[Docket No. FAA-2014-0337; Directorate Identifier 2013-SW-029-AD]

Airworthiness Directives; Various Restricted Category Helicopters

ACTION: Notice of proposed rulemaking (NPRM).

Figure 1 to Paragraph (f)

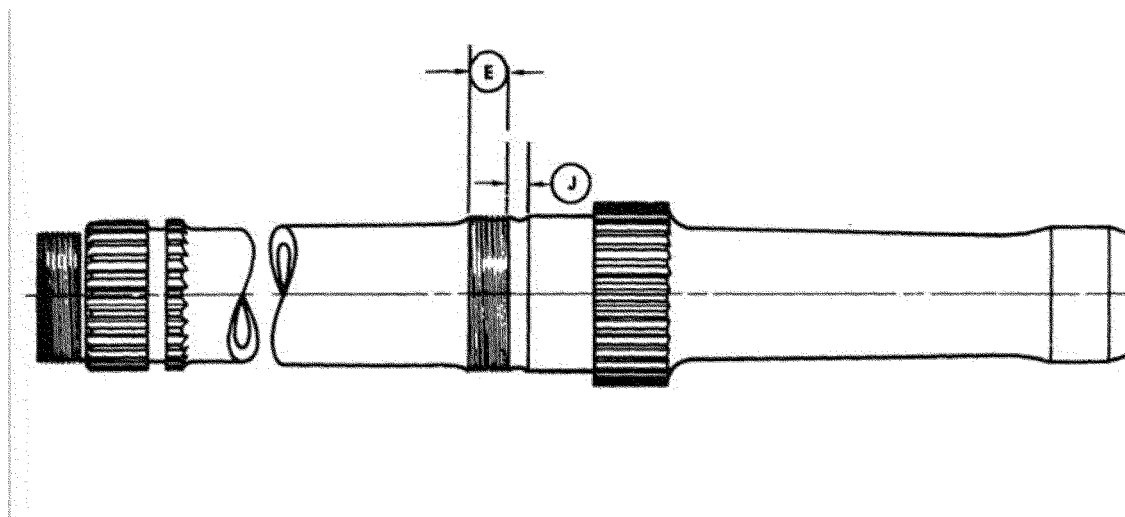
The National Transportation Safety Board (NTSB) commented in support of the required inspection of the threaded area of the mast for a crack, pitting, or corrosion, but requested that the area adjacent to the threaded area (identified in AD 2012–14–11 as “area J”) be added

to the visual inspection requirements of the proposed AD. The NTSB states that a prior accident investigation revealed the mast had fractured in this section. We agree with this comment. Although AD 2012–14–11 does contain a requirement for magnetic particle inspecting the entire mast for a crack, we have included the expanded area in the visual inspection requirements in the proposed AD.

(i) Remove any surface rust with a wire brush or steel wool and, using a 10X or higher power magnifying glass, inspect the areas of the mast as shown in area E and area J of Figure 1 to Paragraph (f) of this AD for pitting, corrosion, or a crack.
